P&Z CASE # _ SP2022-033 P&Z DATE July 12, 202	22 CC D	ATE Approved/Denied
ARCHITECTURAL REVIEW BOARD DATE	_HPAB DATE_	PARK BOARD DATE
Zoning Application  Specific Use Permit Zoning Change PD Concept Plan PD Development Plan		Copy of Ordinance (ORD#) Applications Receipt Location Map HOA Map
Site Plan Application  X Site Plan  Landscape Plan  Treescape Plan  Photometric Plan  Building Elevations  Material Samples  Color Rendering		PON Map FLU Map Newspaper Public Notice 500-foot Buffer Public Notice Project Review Staff Report Correspondence Copy-all Plans Required Copy-Mark-Ups
Platting Application  Master Plat Preliminary Plat Final Plat Replat Administrative/Minor Plat Vacation Plat Landscape Plan Treescape Plan		City Council Minutes – Laserfiche Minutes-Laserfiche Plat Filled Date
HPAB Application  Exhibit		
Miscellaneous Application  Variance/Exception Request	Zoning	Map Updated

PROJECT NAME: Site Plan for Dunkin' Donuts

CASE CAPTION: Discuss and consider a request by John Gardner of Kirkman Engineering for the approval of a Site Plan for a Restaurant with Less

DEPARTMENT	REVIEWER	DATE OF REVIEW	STATUS OF PROJECT	
PLANNING	Henry Lee	06/24/2022	Needs Review

LANDSCAPE PLAN

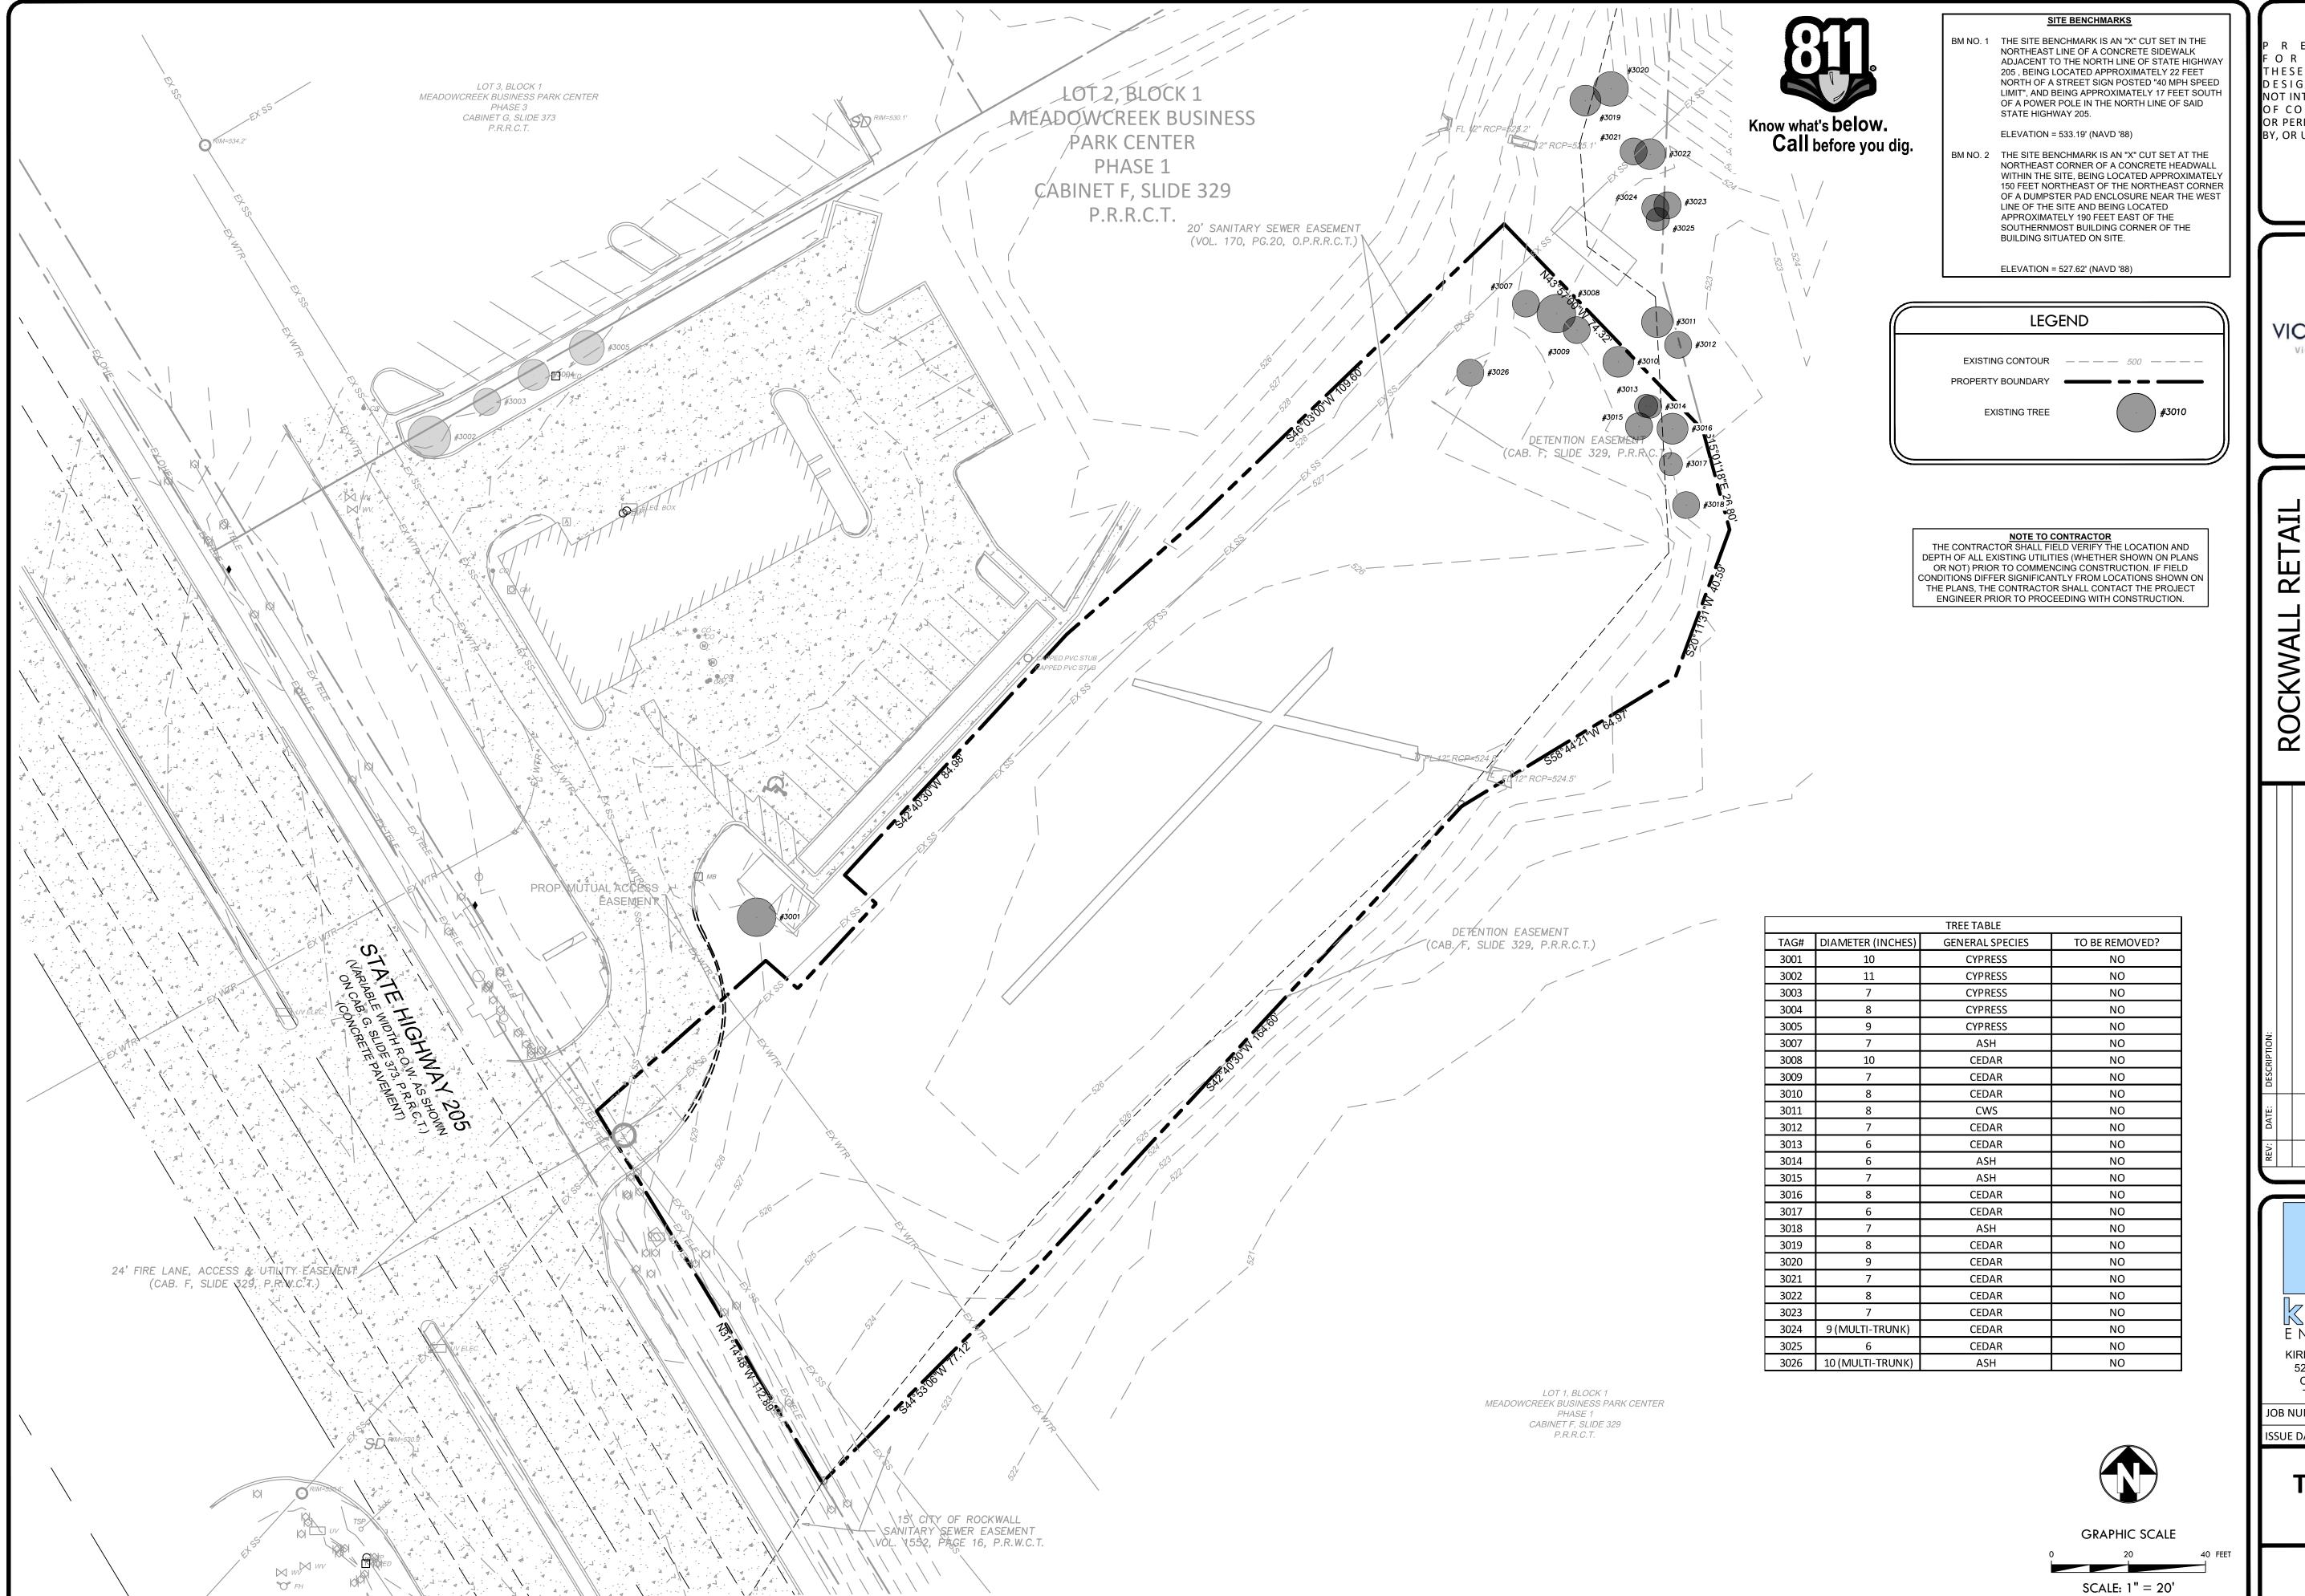
#### M.8 Landscape Plan:

- 1. Provide the same site data as the site plan site data table. (See Sec. 2.1 of this checklist)
- 2. Provide the impervious vs. landscaped area within the site data table. (Subsection 01.01. B, of Article 05)

- 6. Four (4) or more canopy or accent trees shall be planted along perimeter of the subject property to the rear of the building. In this case they could be located along the entry of the drive-through on the north-east side. (Subsection 05.03. B, of Article 08)

- 7. Crape Myrtle are not considered accent trees. Please change out the Crape Myrtles with an accent tree in the landscape buffer. (Appendix C)
- 8. Identify visibility triangles on all lots for all driveway intersections and public streets. (Subsection 01.08, of Article 05)

- 9. Provide a note indicating the irrigation will meet the requirements of the Unified Development Code (UDC). (Subsection 05.04, of Article 08)
- 10. If no trees are being removed from the property we do not need a Treescape Plan.

Sheet Title
SITE PLAN PHOTOMETRIC
Sheet No.

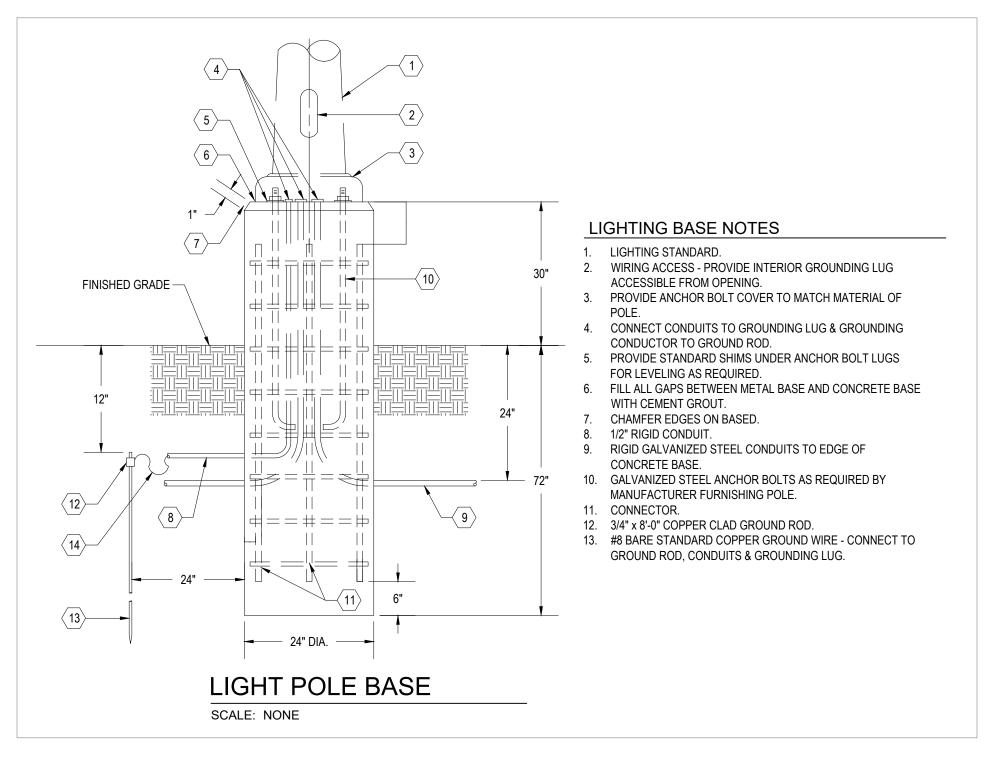
#### M.9 Photometric Plan:

- 1. Provide the same site data information required in Section 2.1 Site Plan: Miscellaneous and Density and Dimensional Requirements of this checklist. (Section 2.1 of this checklist)
- 2. The maximum foot-candles at all property lines must not exceed 0.2 FC. (Subsection 03.03. G, of Article 07)
- 3. Provide cutsheets for all proposed light fixtures. As a note all lighting must be orientated downward. (Subsection 03.03. G, of Article 07)
